ADMINISTRATIVE APPLICATION CHECKLIST

Applicant: OXY USA INC. **OGRID Number:** 16696
Well Name: TAILS CC 10-3 FEDERAL COM 35H **API:** 30-015-48965
Pool: PURPLE SAGE WOLFCAMP **Pool Code:** 98220

Re: ***Application for Administrative Approval of Non-Standard Location
Tails CC 10-3 Federal Com 35H – Purple Sage Wolfcamp
Surface – 220' FSL 1705' FEL Unit O Sec 10 T24S R29E
First Take Point – 100' FSL 1000' FEL Unit P, Sec 10 T24S R29E
Last Take Point – 100' FNL 1000' FEL Unit A, Lot 1, Sec 3 T24S R29E
Bottom Hole – 20' FNL 1000' FEL Unit A, Lot 1, Sec 3 T24S R29E
Eddy County, New Mexico***

CC: Tails Wolfcamp 1280-acre HSU Well Layout

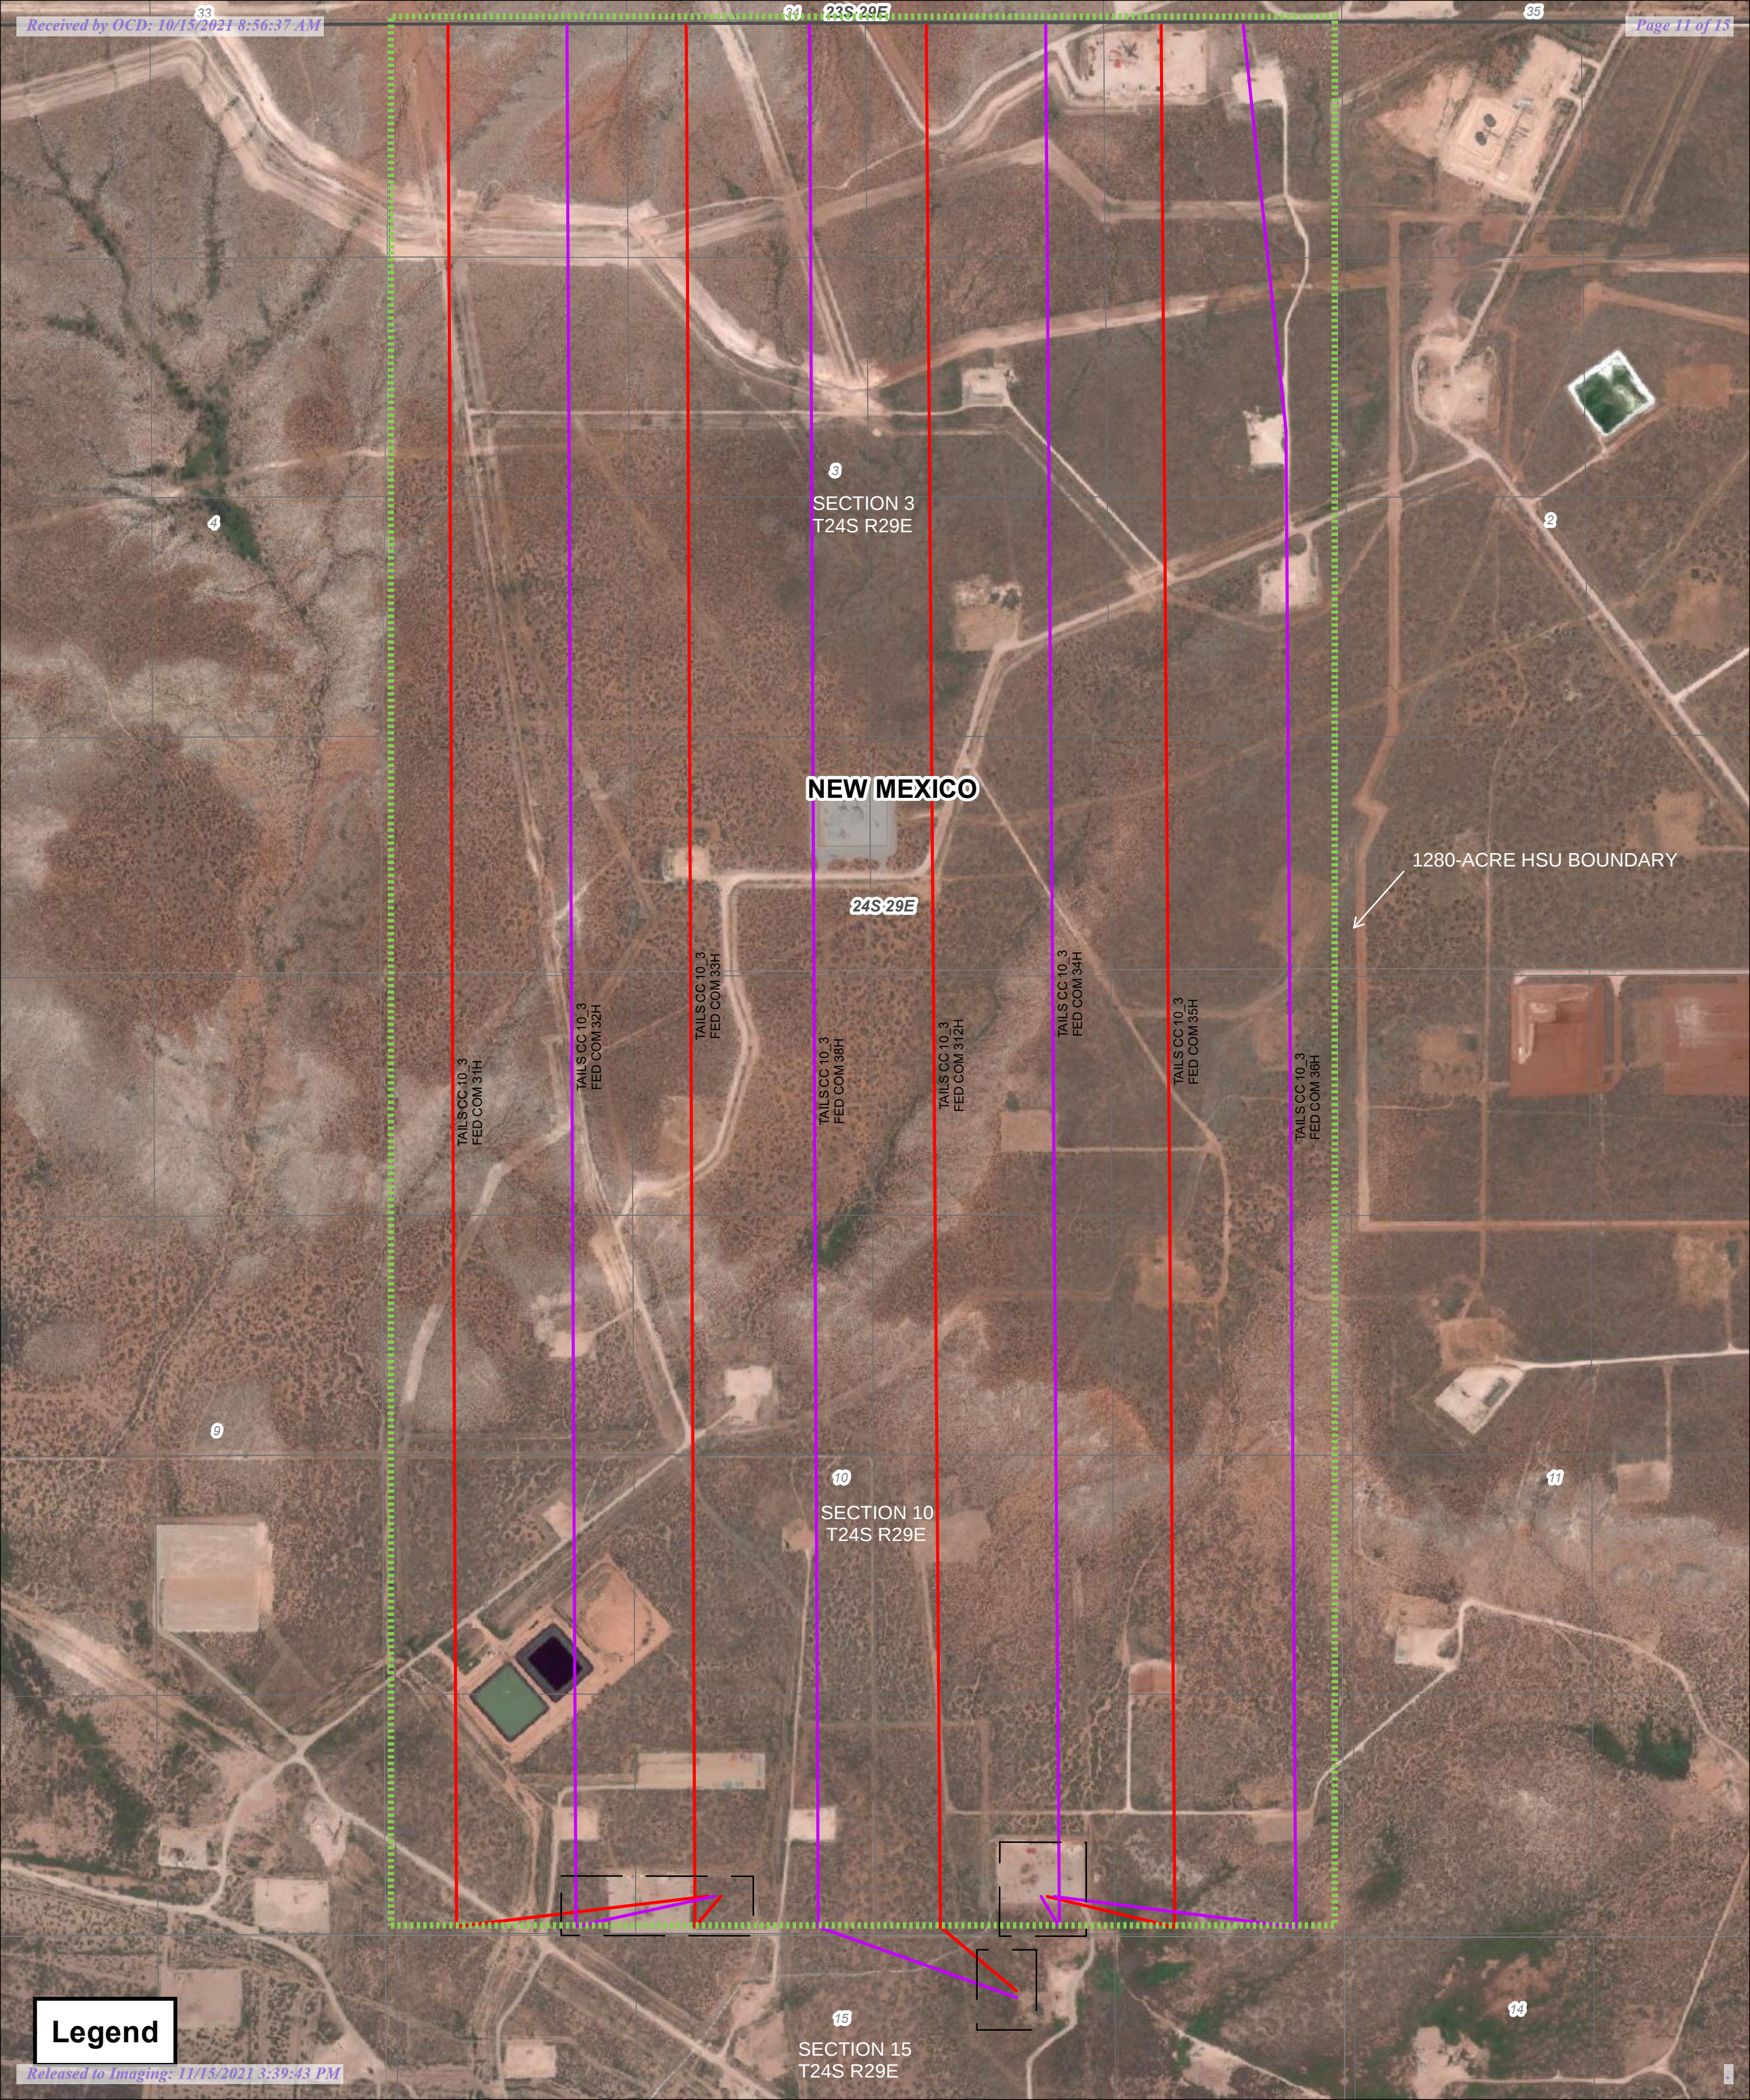
The spacing unit pertaining to your Tails CC 10 3 Federal Com wells are all seeking 1280 acres as their Horizontal Spacing Unit.

The Purple Sage; Wolfcamp is regulated to 320 acres for a projected horizontal spacing unit allowed by order. Any irregular spacing unit (greater or less HSU) needs to be approved by an OCD Administrative Application of a NSP. Unless the operator can prove that the horizontal spacing unit stated for all these wells are allowed by other means. If so, what are those?

OXY USA Inc. respectfully requests administrative approval of a non-standard location on the below list of Tails CC 10-3 Federal Com wells. The #38H well will be the defining well for the 1280-acre HSU and for the proposed completed wells in the Purple Sage Wolfcamp pool, Pool Code 98220. Attached is the well layout for the 1280-acre horizontal spacing unit for the Purple Sage Wolfcamp pool.

Here is a letter and the well layout for the PSW spacing unit. Let me know if this works or if I need to add in anything.
